Re: 2-6 GIRAWAH PLACE, MATRAVILLE
Project No: 22031T

I refer to your request to provide further traffic engineering input to the proposed mixed-use development at the above address in response to additional traffic and transport comments received from Randwick City Council on 2 November 2023.

ATTACHMENT 1

HORNE GROUP PTY LTD
PROPOSED MIXED USE DEVELOPMENT
2-6 GIRAWAH PLACE
MATRAVILLE
B99 DESIGN VEHICLE SWEEP PATHS

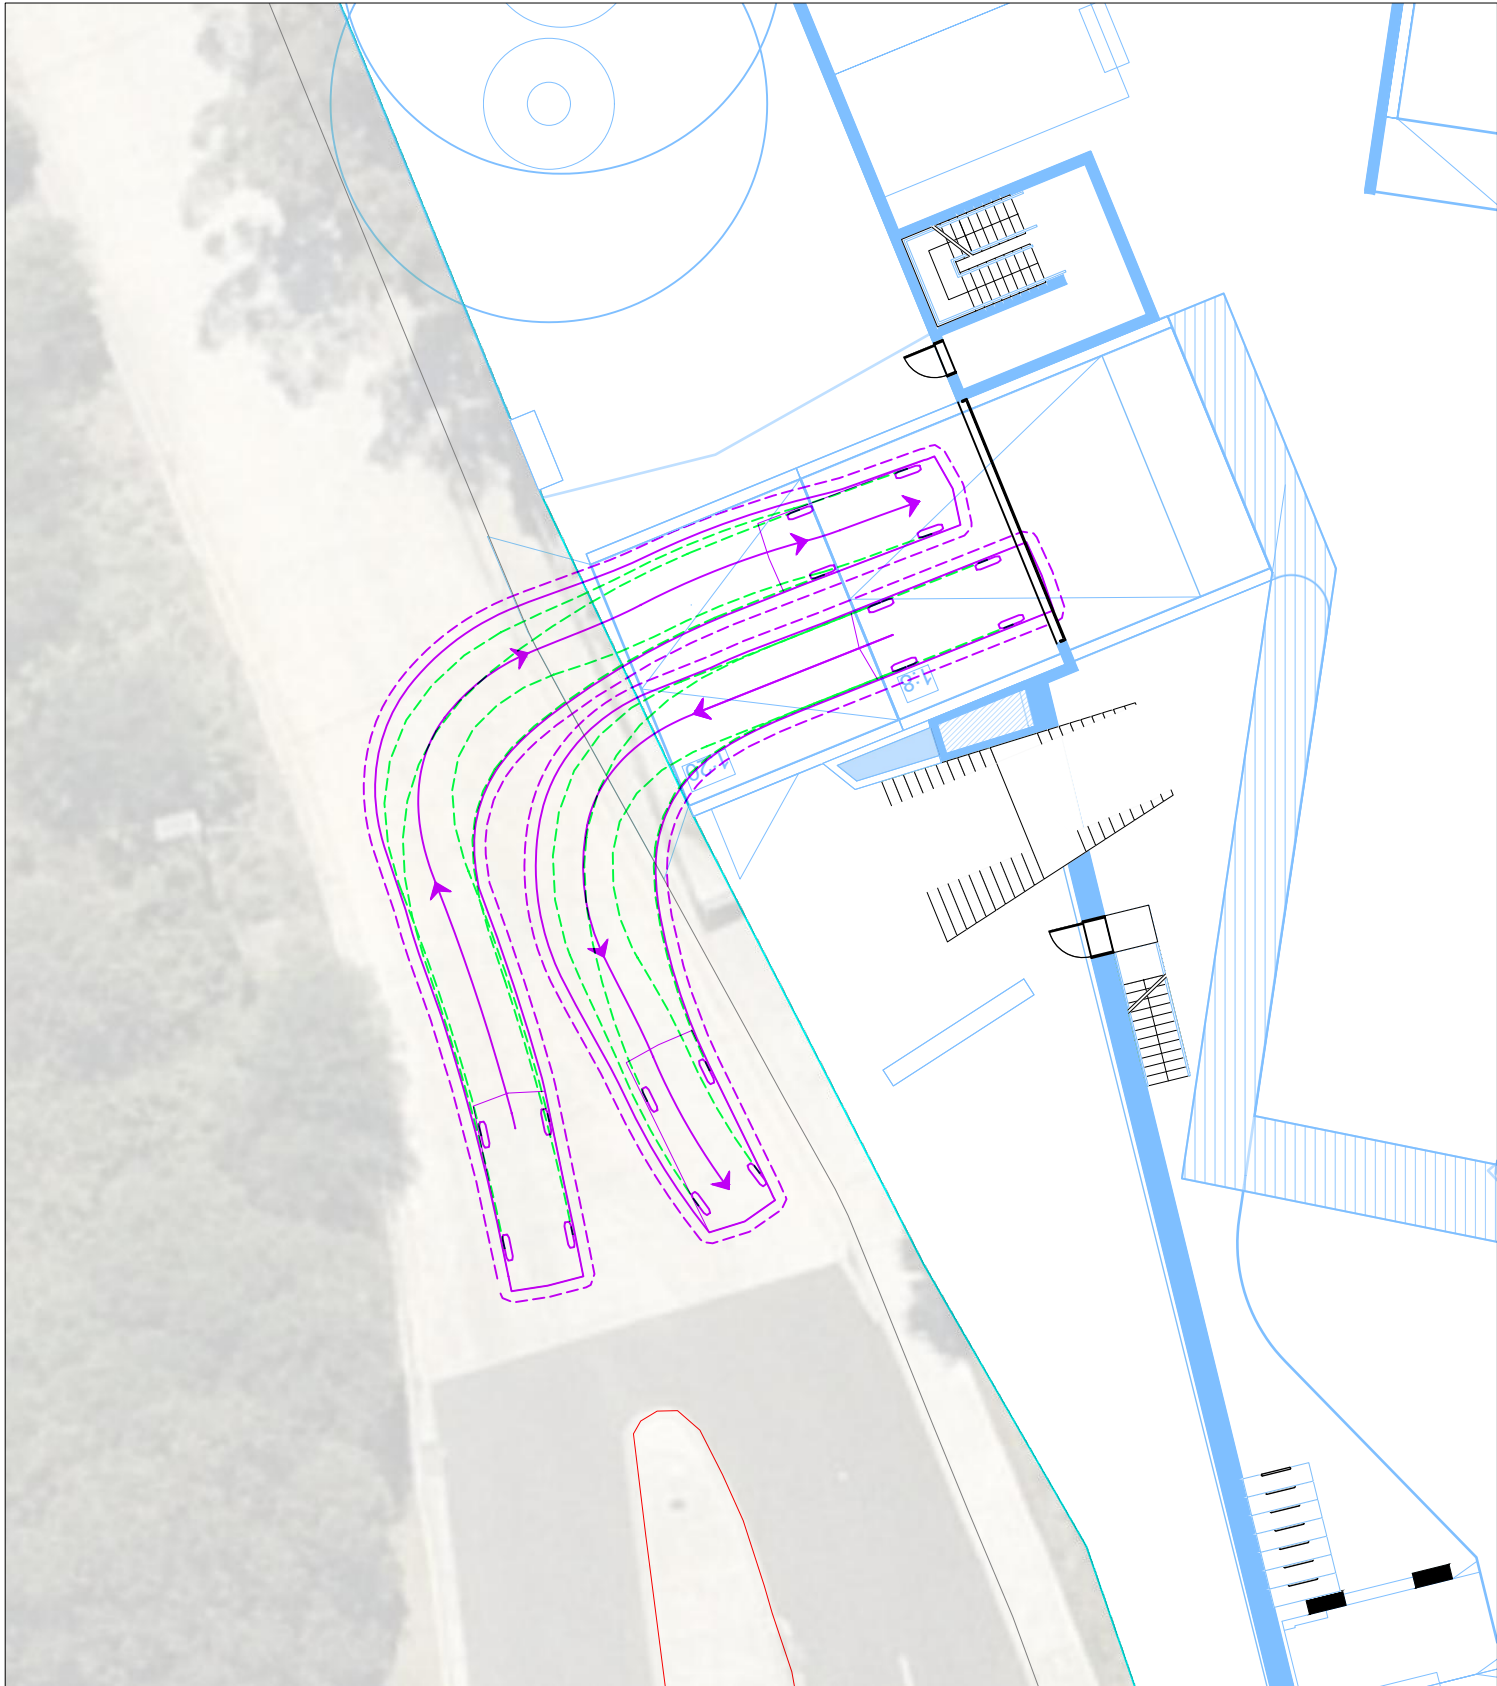
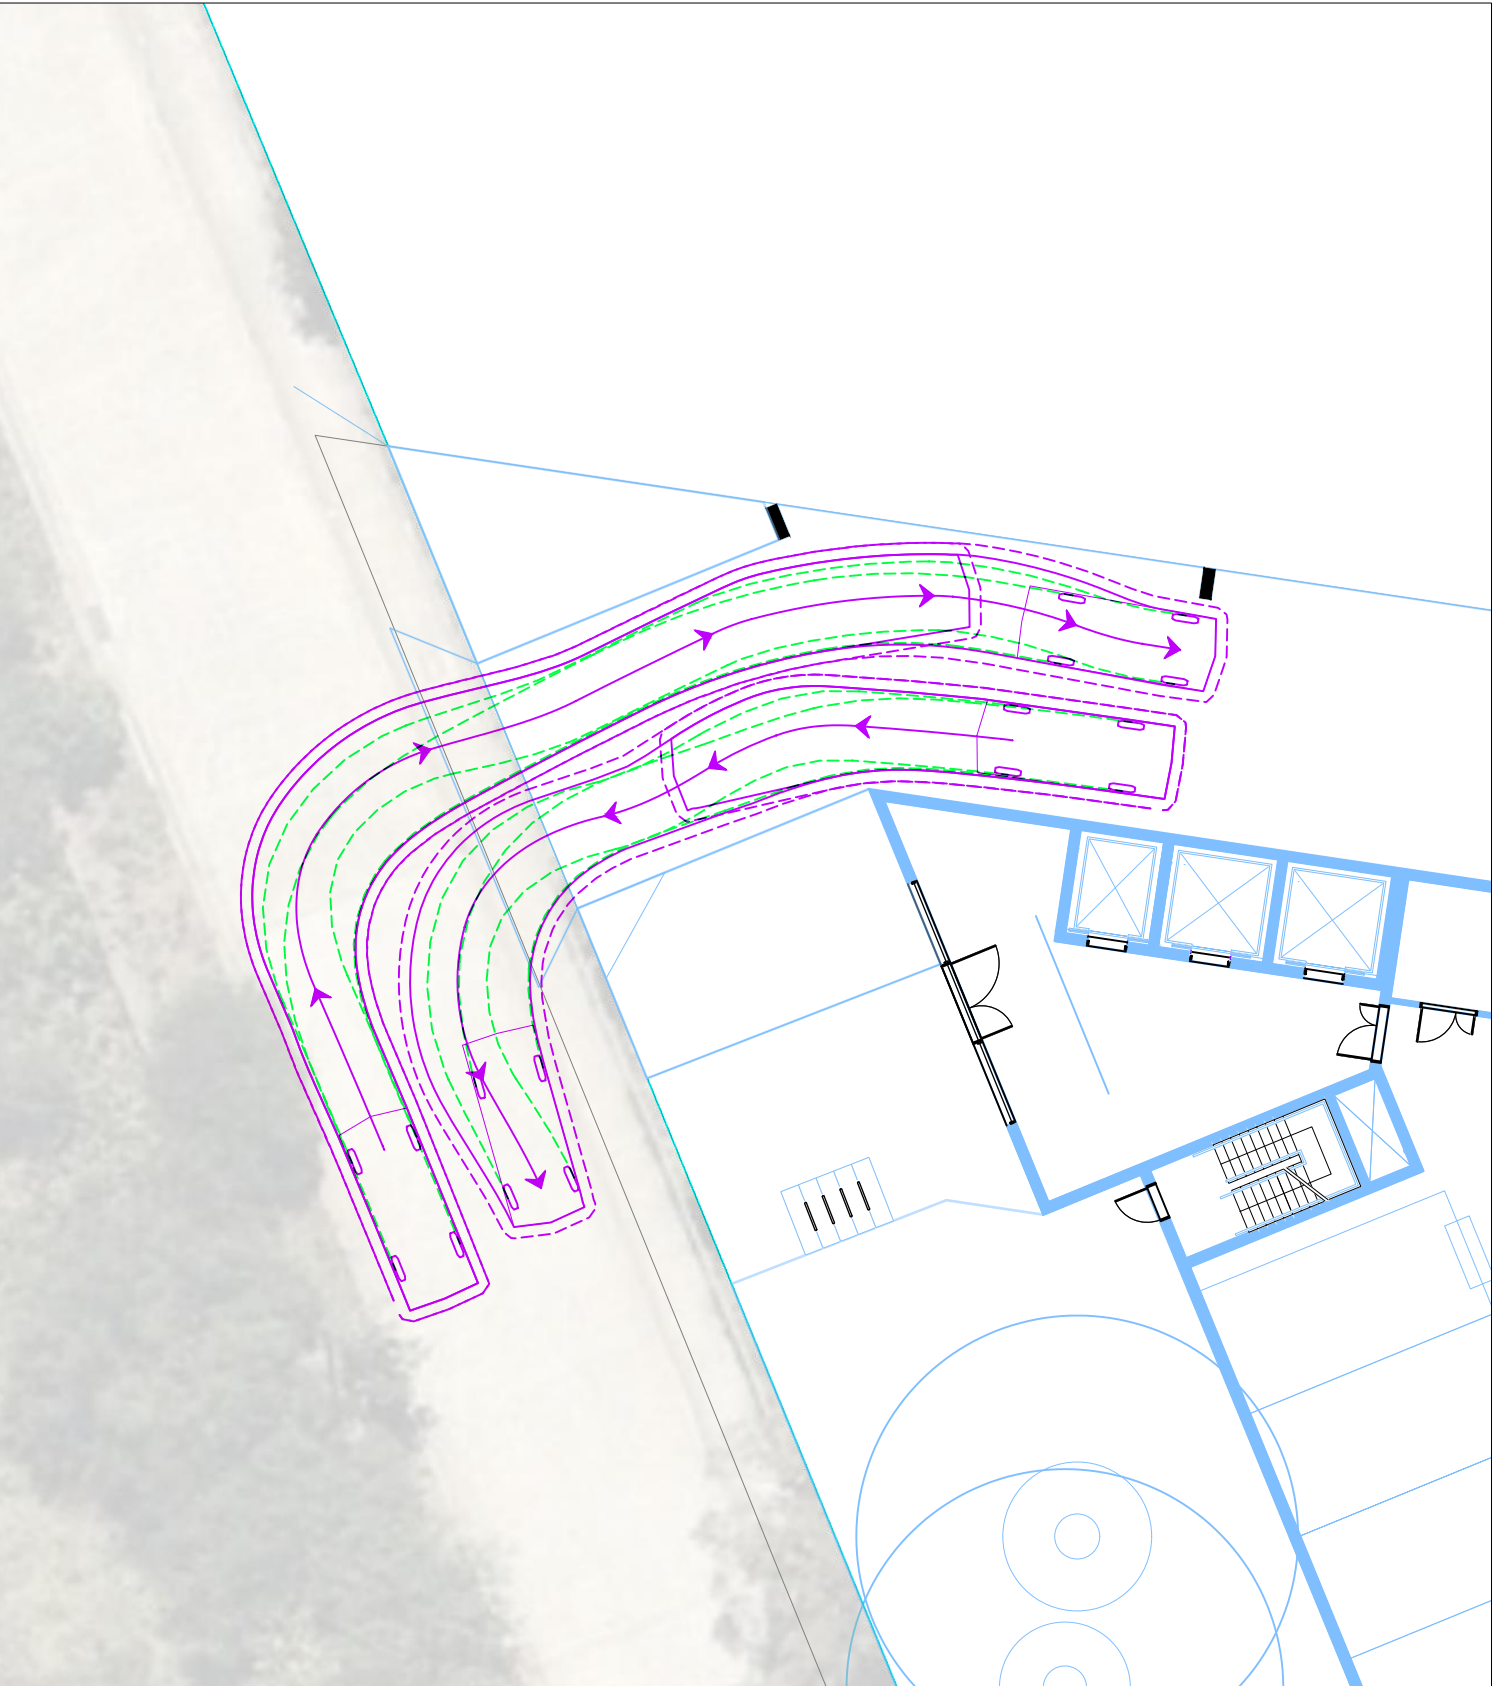
- 2. The southernmost driveway access is considered to be a Category 3 accessway under AS2890.1, for which a separated entry and exit is required. The current combined access is non-compliant, and not considered suitable for a development of this scale. Furthermore, it must be clearly demonstrated that pedestrian sight splays are maintained as per Figure 3.3, AS2890.1. Noting the scale of the site, consideration should be given towards exceeding the minimum sight line requirements.*

- 3. The northernmost driveway shall be redesigned so as to intersect the roadway at a perpendicular angle. All driveway widths, grades and pedestrian and intersection sight distances shall be achieved as per AS2890 requirements.*

Swept paths demonstrate that vehicles are able to pass simultaneously at the site access and along the driveway, refer to attachment 1.

Noted, the northernmost driveway has been redesigned to intersect Girawah Place at a perpendicular angle and continue to meet the requirements of AS2890. Swept paths demonstrate that concurrent inbound and outbound traffic movements are possible at the site access and along the driveway.

Refer to attachment 1 for swept path analysis of the revised driveway.
